PRODUCT CHANGE NOTIFICATION

Select Bourns® Model SMCJ, ~~1.5SMC~~ & SMLJ Series Commercial Grade TVS Diodes

Automated Assembly Process and Uniform Die Size

ESD2303REV

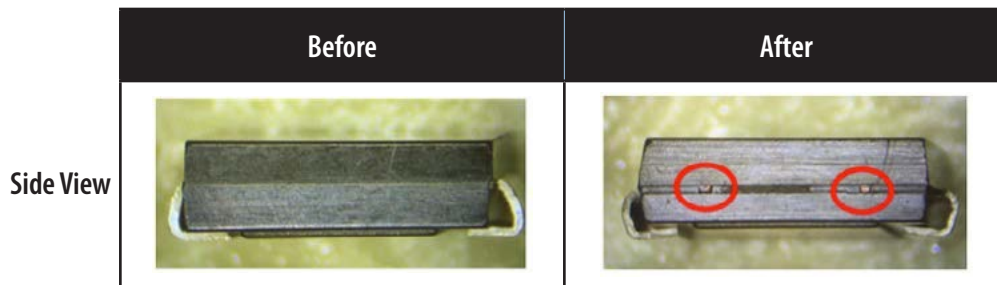
The changes will affect the form of the product, as depicted below. With the new process, tie bars will be visible at the side of the package, but there is no internal connection between these tie bars.
